BULLETIN #142

SYNCHRO-PULSE CDT 450

MAIN PCB RESETTING

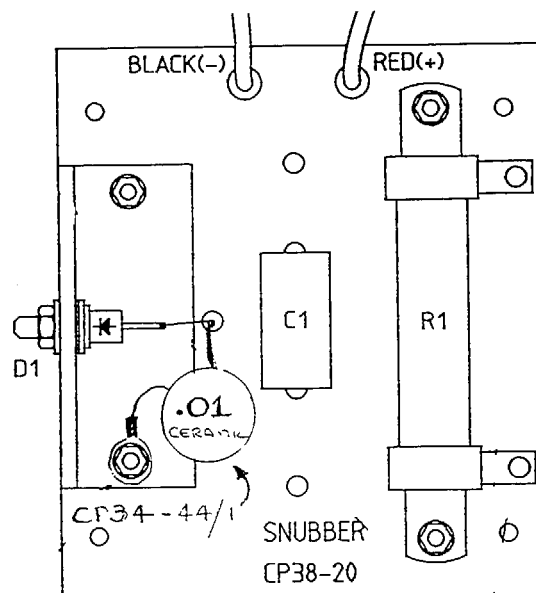
The source of the electrical noise has been traced to diode D1 of the main switch snubber circuit CP38-20, and is associated with the faster switching characteristics of some recently received parts.

Fortunately the problem can be readily corrected by the installation of a .01mfd ceramic type capacitor (WIA Part No. CP34-44/1) directly across the diode. Please refer to the sketch below for a suggested method of field installation of the diode.
